STAFF REPORT: AUGUST 13, 2025 REGULAR MEETING

APPLICATION NUMBER: HDC2025-00418

ADDRESS: 1485 BURNS AVENUE

SCOPE: REPLACE STORM WINDOW WITH VINYL CASEMENT WINDOW

Submitted by applicant, image shows 1485 Burns rear view with second floor windows (highlighted window which is being proposed for alteration)

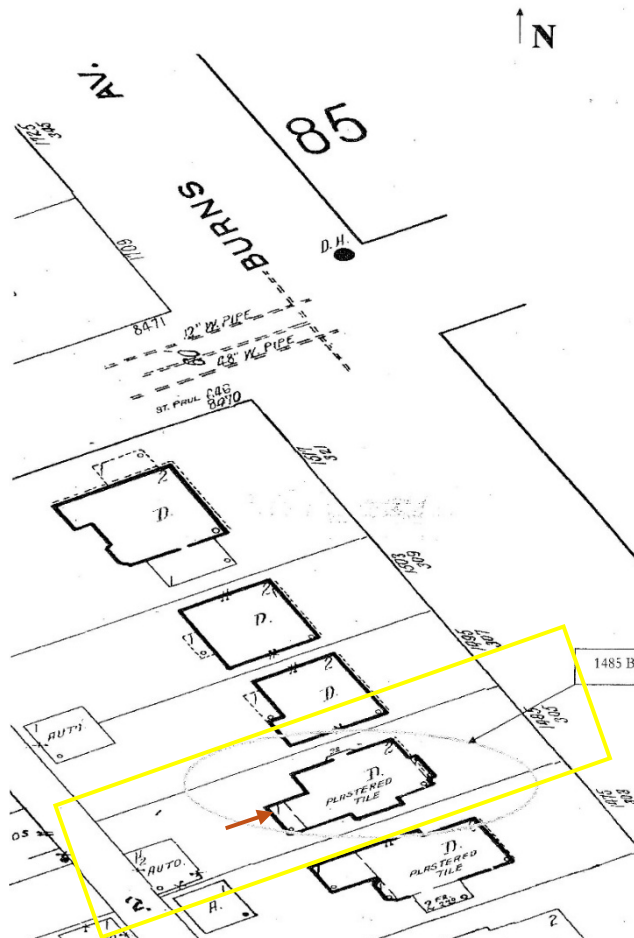
The existing rear window and window frame are wood, which is a compatible material type within the historic district. Both the wood window and the existing aluminum storm window appear to be in good condition and are not deteriorated beyond repair.

- The vinyl casement window that is being proposed to replace the aluminum storm window is not compatible within the historic district for the following reasons:

- Vinyl windows and poly-products offer plasticity and flat/thick appearance that does not adequately match the profile/dimensionality and appearance of historic windows, such as wood

- Consumer-grade vinyl windows weather poorly, deteriorate rapidly and exhibit poor detailing and detracting "bright white" color/sheen.

- The standard relationship of windows to walls is that windows are recessed within walls and therefore the addition of a vinyl casement window to the already existing window is not an appropriate design solution. The historically appropriate solution is to install a new aluminum or wood-framed storm window.

- Vinyl is not a suitable material for replacing windows within a historic district.
- There is no historic precedent for installation of another full window outboard of an existing historic window. A compatible replacement storm window should be considered.

- Therefore, it is staff's opinion that the addition of the vinyl casement window is not an acceptable alteration for this house within the Indian Village Historic District.
